HANFORD FEDERAL FACILITY AGREEMENT AND CONSENT ORDER  
CHANGE REQUEST M-17-91-05A (HANFORD WASTEWATER DISCHARGES)

Change Title <p style="text-align: center; font-weight: bold; margin-top: 10px;">RENEGOTIATION OF M-17-00 LIQUID EFFLUENT MILESTONES - MODIFICATION OF CHANGE PACKAGE RESULTING FROM PUBLIC COMMENTS</p>		
Description/Justification of Change <p>As part of the <u>Hanford Federal Facility Agreement and Consent Order</u> (Tri-Party Agreement or TPA), Washington State Department of Ecology (Ecology), U.S. Environmental Protection Agency (EPA) and U.S. Department of Energy (DOE) conducted a 45-day public comment period (March 5-April 22, 1992) to obtain public comments regarding proposed changes to Milestone 17, the milestone that manages Hanford's liquid effluent or wastewater discharges. These proposed changes were contained in TPA Change Request M-17-91-05. See continuation on Page 2.</p>		
Impact of Change <p>This change will provide a more inclusive set of milestones and a greater level of regulatory control and oversight of liquid effluents at the Hanford Site. It should be noted that this change does not affect interim milestones M-17-06A through M-17-06E.</p>

Item Num

Figure 9-2. Part B Permit Application and Closure/Postclosure Plan Process Flowchart.

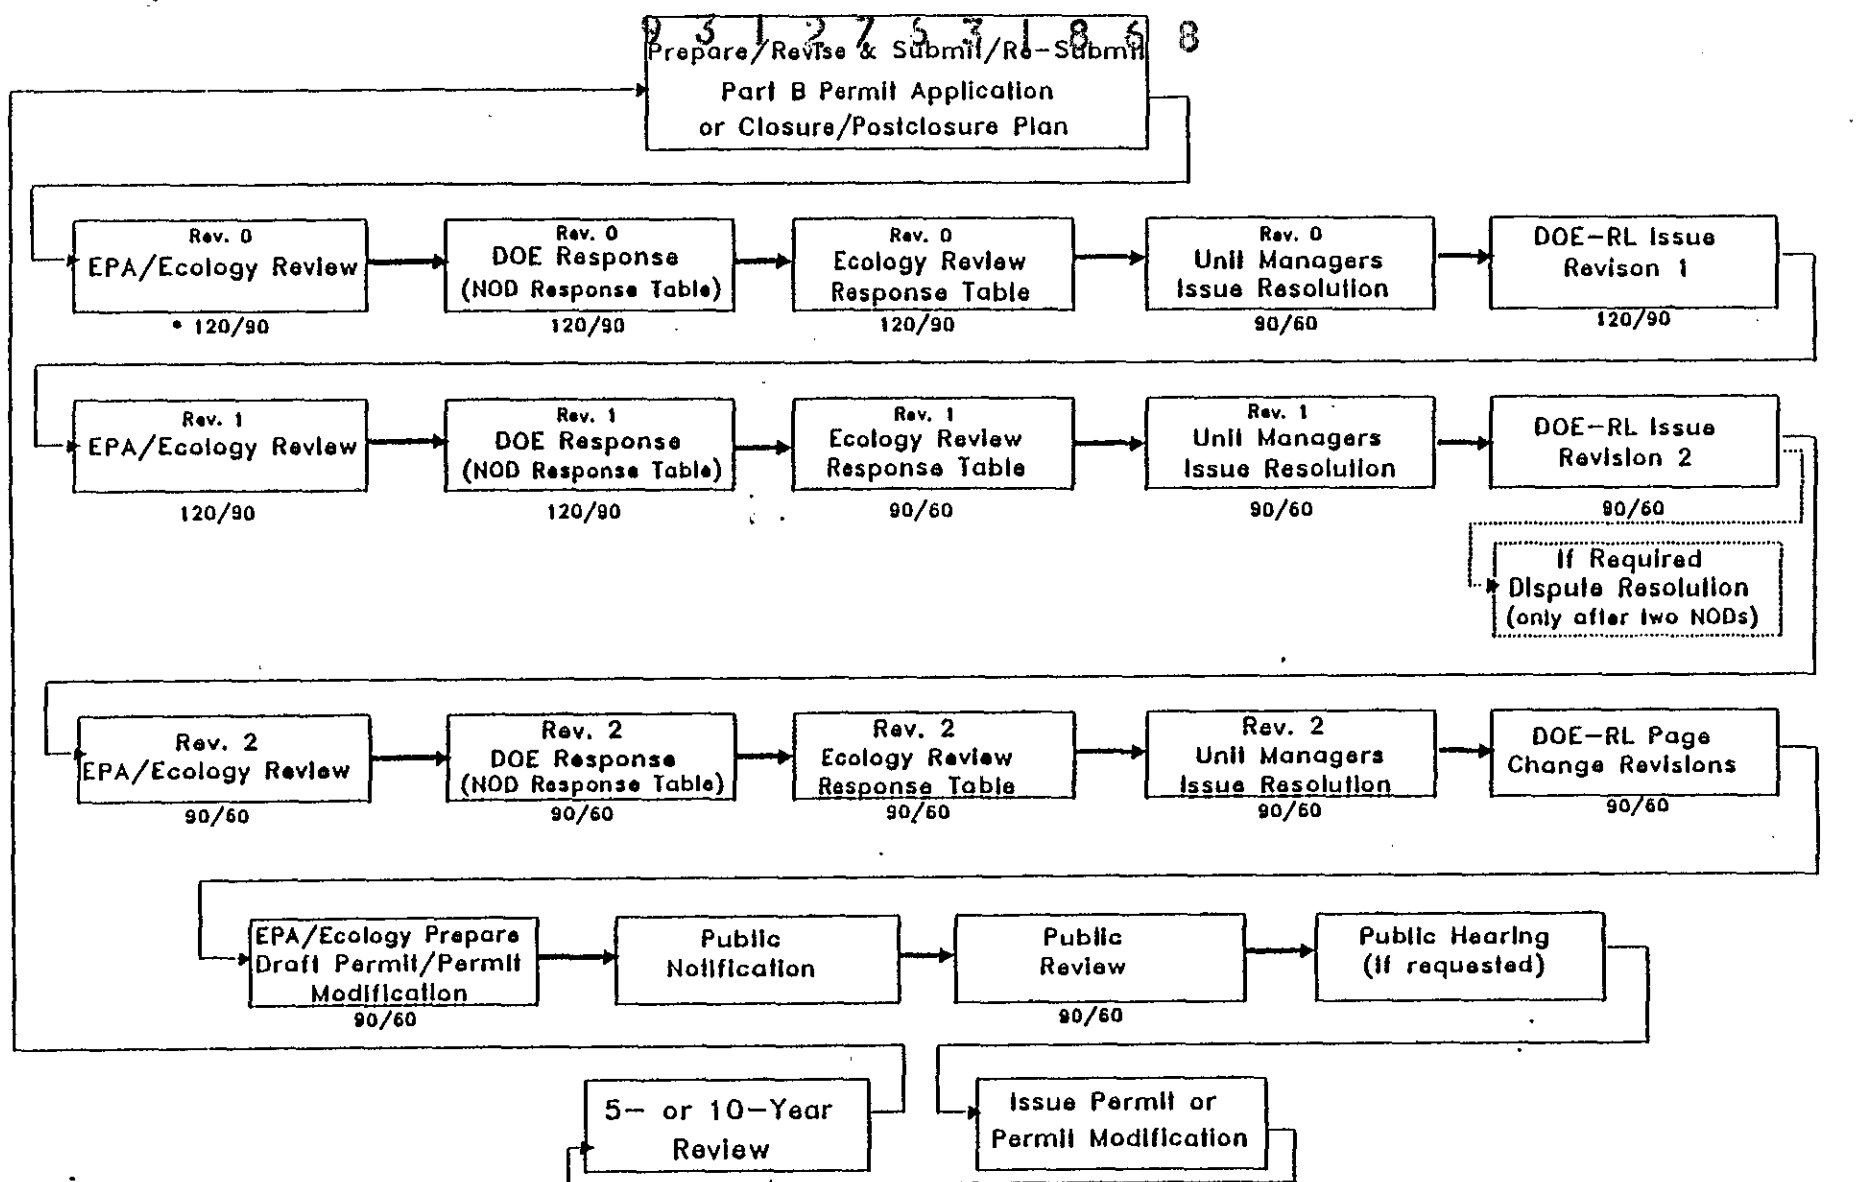
Item Number	Location	Change
		response summary and incorporated in accordance with 173-303-840(7) and (9) WAC. Public hearing opportunities are further discussed in Section 10.7.
5.	Figure 9-2	Delete current Figure 9-2 and replace with new Figure 9-2 as displayed on next page of this amendment.
